**Subject: Response to Portion of NRC Request for Additional Information
Letter No. 43 Related to ESBWR Design Certification Application –
ESBWR Containment Design and Probabilistic Risk Assessment Re:
Containment Fragility Analysis – (Release A) RAI Numbers 6.2-95,
6.2-97, 19.2-41, 19.2-44 to 19.2-46, 19.2-49, 19.2-50 and 19.2-57**

1. MFN 06-268 – Partial Response to NRC RAIs 6.2 and 19.2 Release A RAI 6.2-95, -97, 19.2-41, -44, -45, -46, -49, -50 and -57
2. MFN 06-268 – DCD Section 6.2 and NEDO 33201 Table B.8-1 Markup Pages for RAIs 6.2-95, & -97, and RAI 19.2-45c

**Partial Response to NRC RAIs 6.2 and 19.2 Release A
RAI 6.2-95, -97. 19.2-41, -44,-45, -46, -49, -50 and -57**

Figure 19.2-45(1) Locations of the data in PRA Table B.8-1 as indicated in Table 19.2-45(3). Upper Drywell and Wetwell.

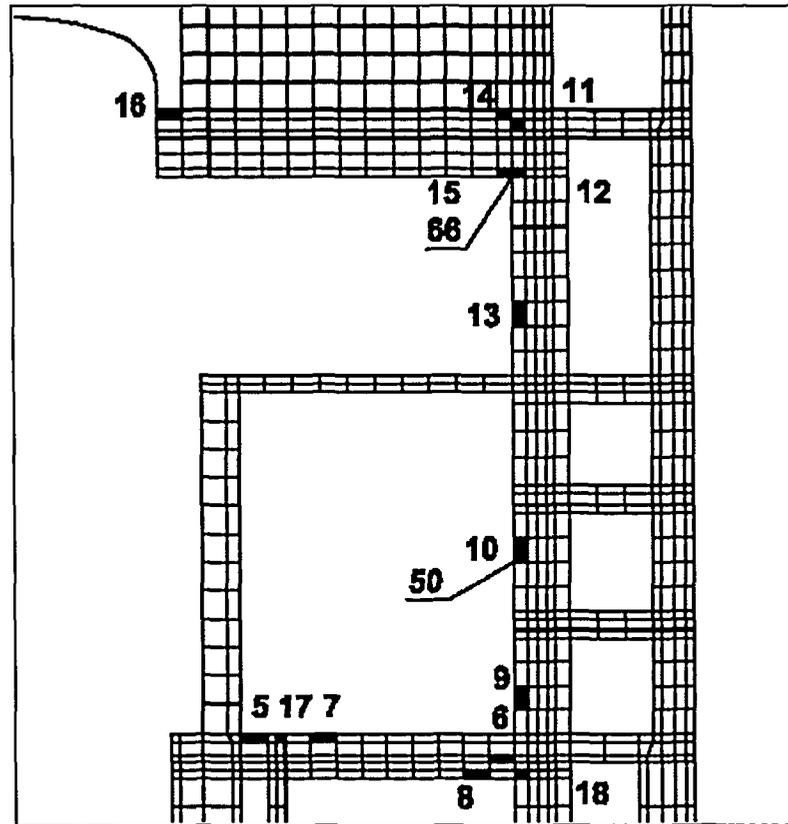
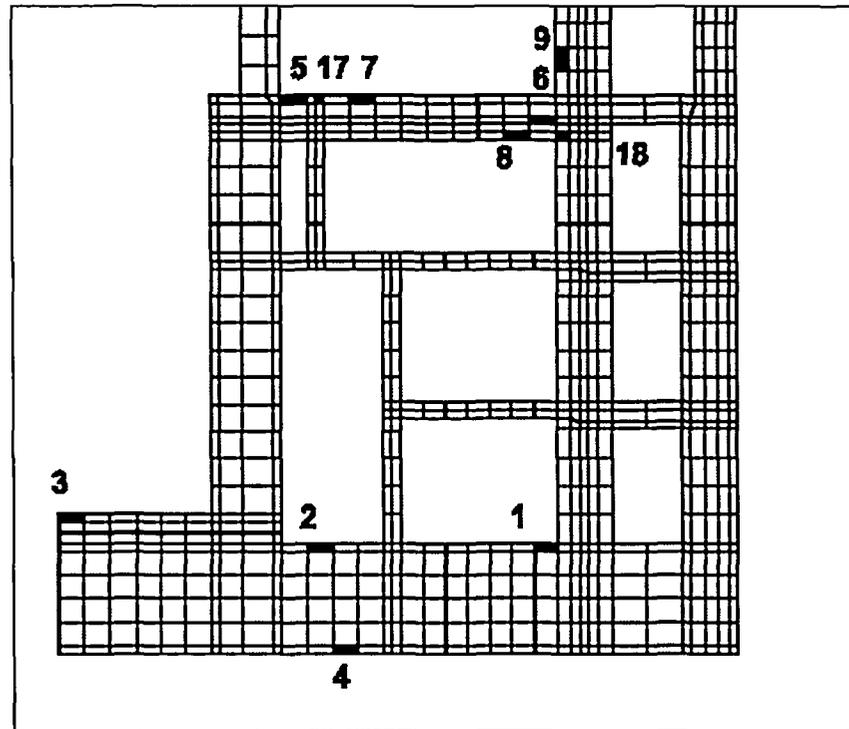
- d) Provide the max. rebar strains (including locations) at each pressure level for all components in Table B.8-1, and provide a discussion of comparisons of max. rebar strains with the max. liner strains listed in Table 8.1-1.*

- f) What is the radius at the location of the reported "Max. Radial Defl. Wetwell", and what are the calculated strains at this location (i.e., radial deflection divided by radius)? Compare to the rebar strains.*

- d) Table 19.2-45(2) and 19.2-45(3) show the maximum rebar strain at each pressure level for all components in Table B.8-1. as well as their locations. See response to RAI 6.2-95 for a detailed comparison of rebar strains and liner strains at 1.468 MPa.

- f) The reported Max. Radial Deflection, is the maximum radial displacement in any point of the containment. In this case it is measured in the middle of the wetwell and is 13.02 mm. For a 18,000 mm inside radius of the containment, radial strain is 0.072%. Radial strain for the rebars in the same location is 0.017% (point 50 in Figure 19.2-45(1)) which is the same order.

Figure 19.2-57(2). Thermal Contours RCCV Wall under DCH with Large Breach

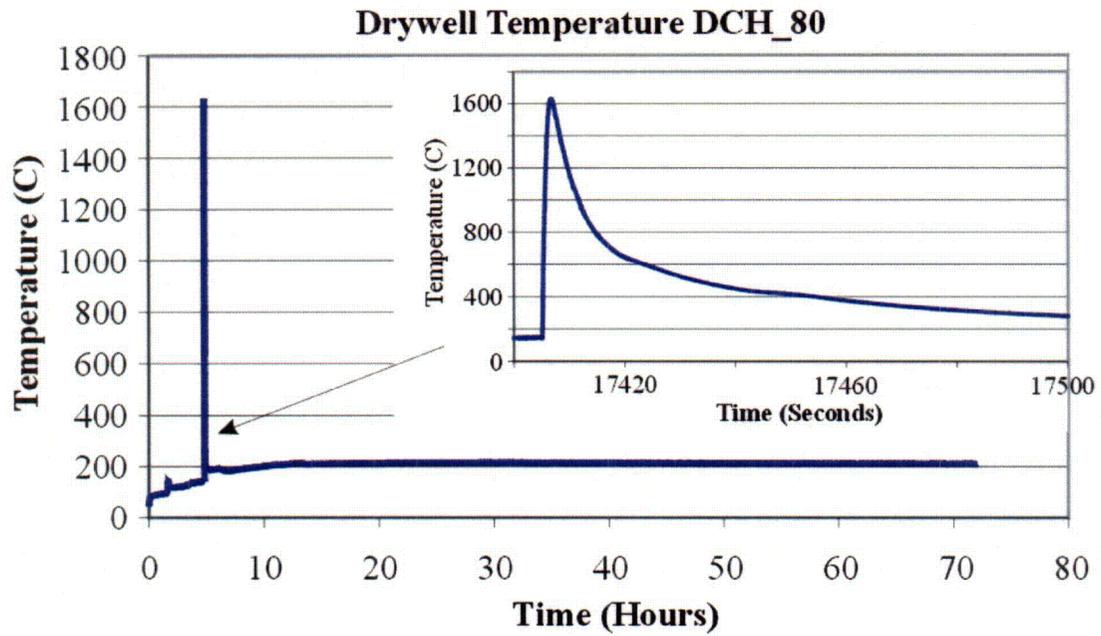
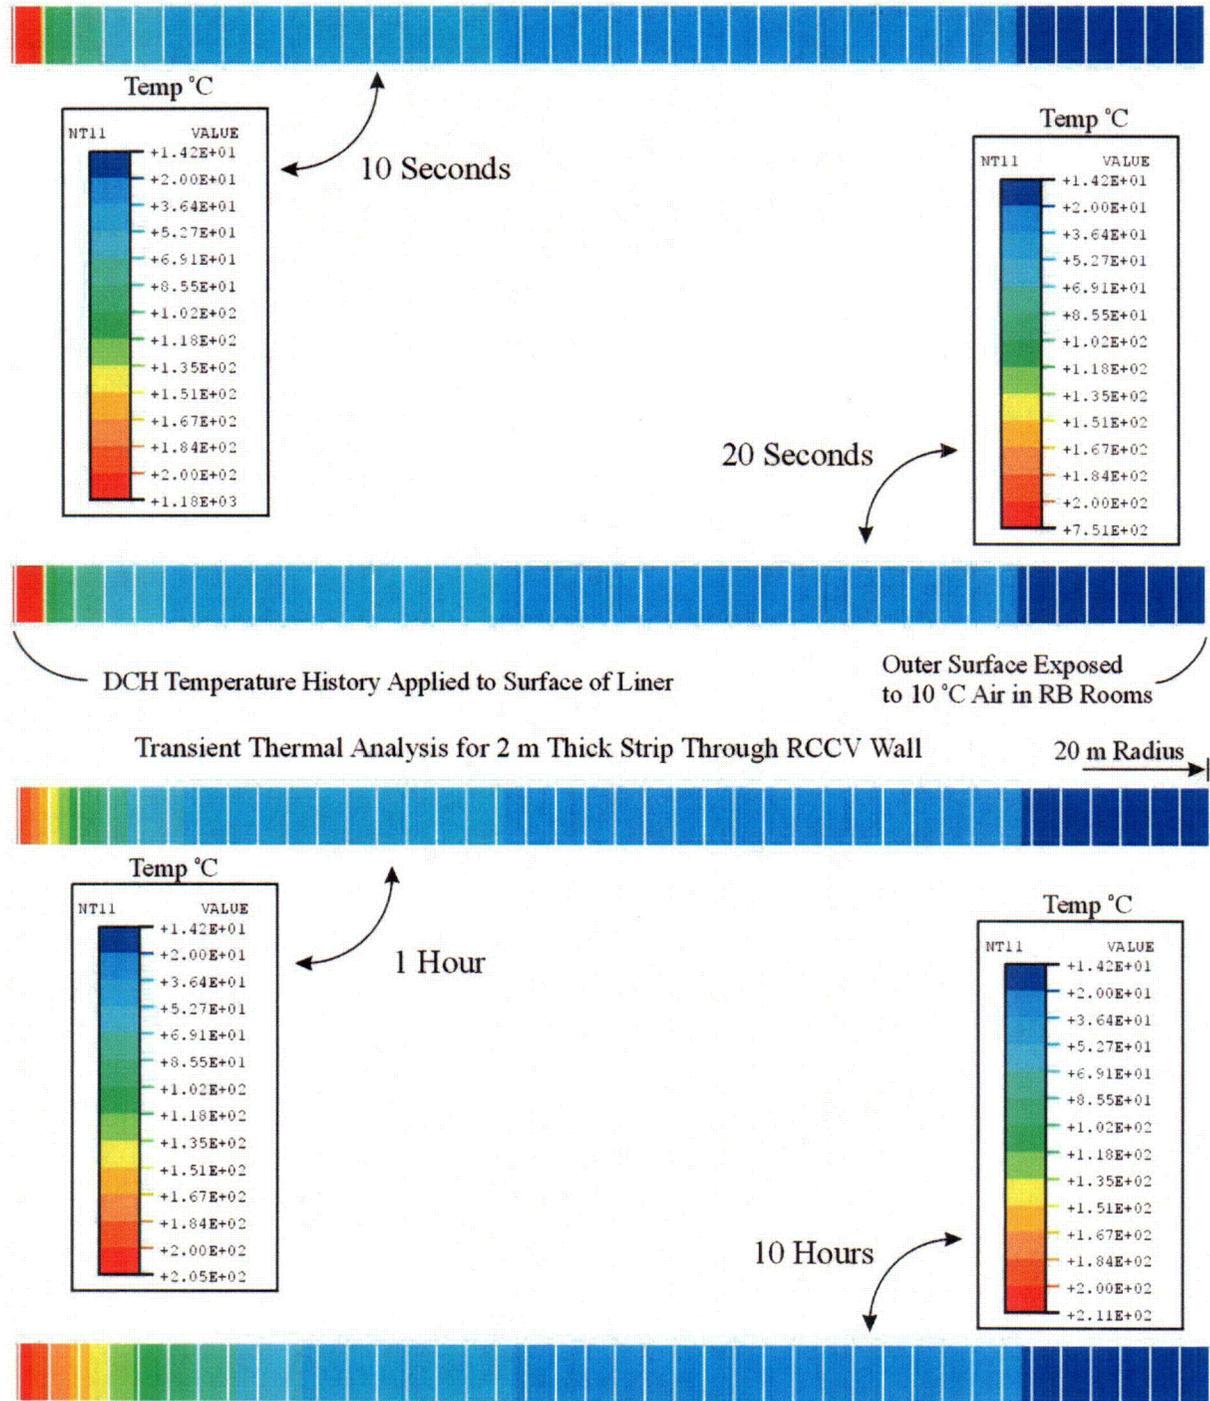
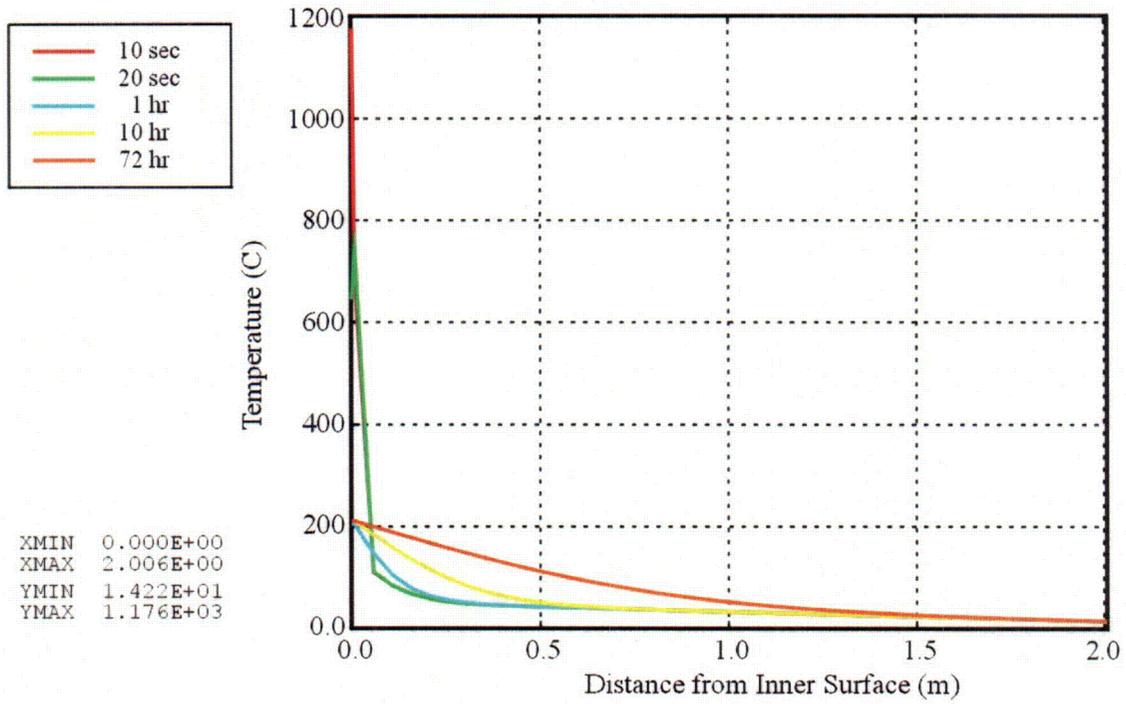
In PRA, Section 21.3, GE described that the DCH generated superheated gas could induce temperatures in excess of 1000°K in the upper drywell space. It is not clear how the concrete performs under such high temperatures. Provide:

- a) Calculations were carried out with the MAAP code to determine the long-term temperature history of the upper drywell atmosphere under the assumption that the PCCS and BiMAC systems were functional. We considered a bounding case as found in Section 21 of NEDO-33201 Rev 1 analysis of the DCH event, and we made sure that the starting point of this long-term, systems analysis matched the post-DCH temperature levels found in the DCH event assessment of Section 21 of NEDO-33201 Rev 1. The result is shown in Figure 19.2-57(1). Note as a result of the cooling systems the DCH-induced high temperature spike is just that; in other words it is seen to dissipate in a matter of a few seconds, reaching down to less than 3000 C in ~1 minute. From then on the temperatures decay slowly down to 2000 C in less than 1 hour where it seems to stabilize for the long term (72 hours and beyond).

We then proceeded to find an upper bound heat up of the concrete by imposing this temperature history on the inner surface of the liner (that is assuming an infinite heat transfer coefficient) along with a gap conductance that was kept conservatively low for the duration of the transient. The results are summarized in Figure 19.2-57(2) and Figure 19.2-57(3). First it is interesting to note that the atmospheric spike attenuates already by the liner, with a peak of only 8000 C. Then we note that the combined effect of slow conduction into the concrete along with the rapid cooling of the atmosphere yields a very slow penetration of a thermal wave whose peak value on the surface is just under 2000 C.
